Proposed Revisions to a Standard Plans Index

Index Number: 715-001

Index Title: Conventional Lighting

METAL POLE WIRING DETAIL

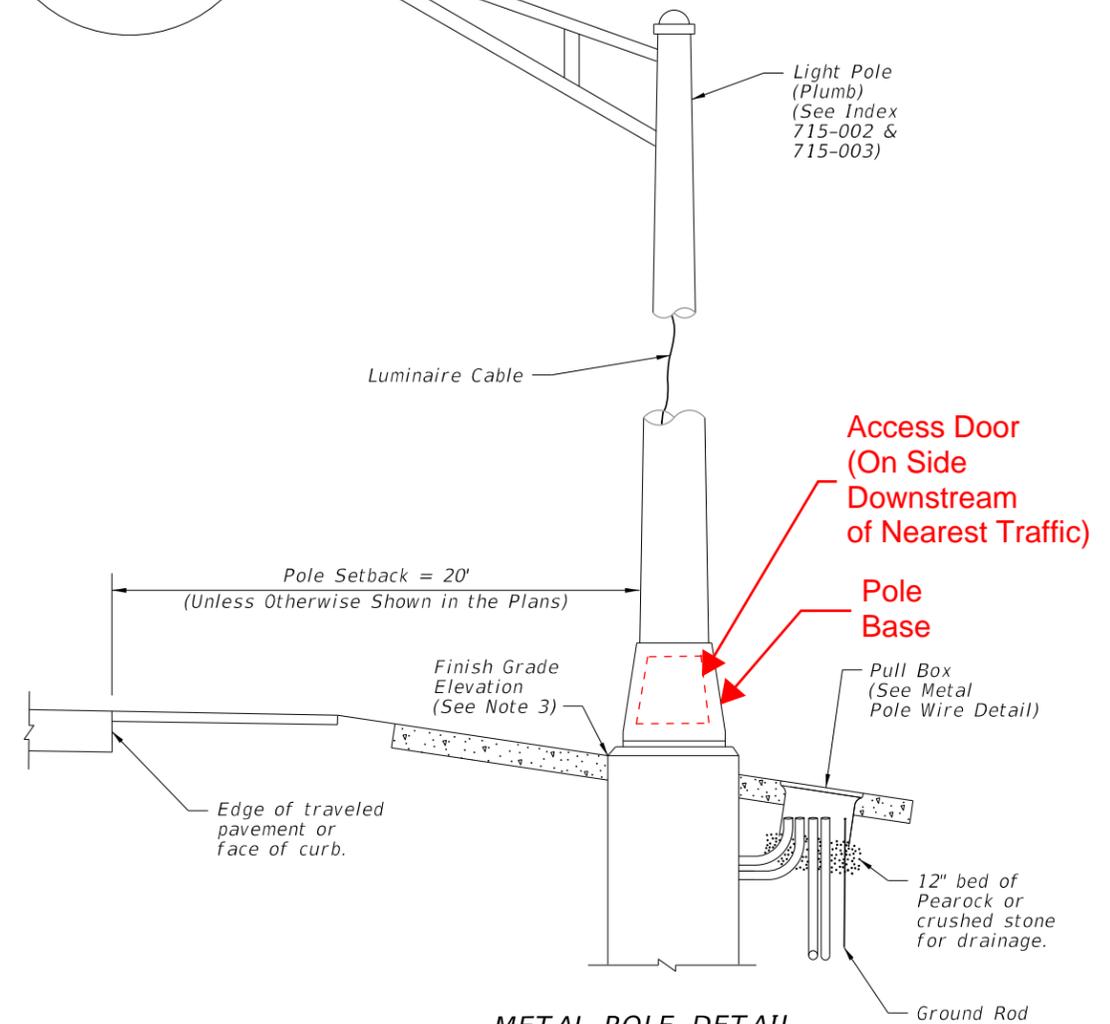
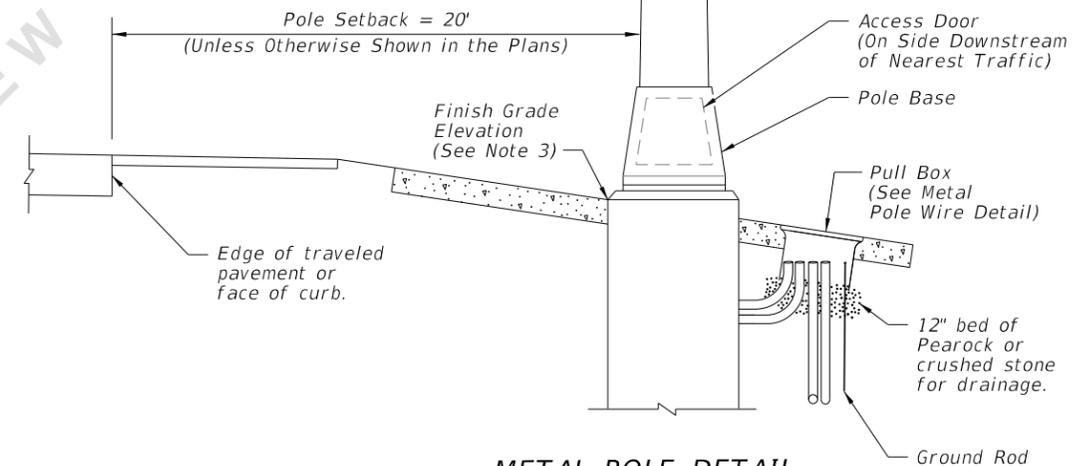
Sheet 1: Deleted the "Access Panel" drawing and added a "Pole Base" callout on the 'Metal Pole Wiring Detail'.
Added the "Access Door" drawing and a "Pole Base" callout on the 'Metal Pole Detail'.

The details were revised to locate the Access Door on the downstream side of the Pole Base for better consistency with Standard Specifications 715-13.1. The downstream side is relative to the nearest traffic movement.
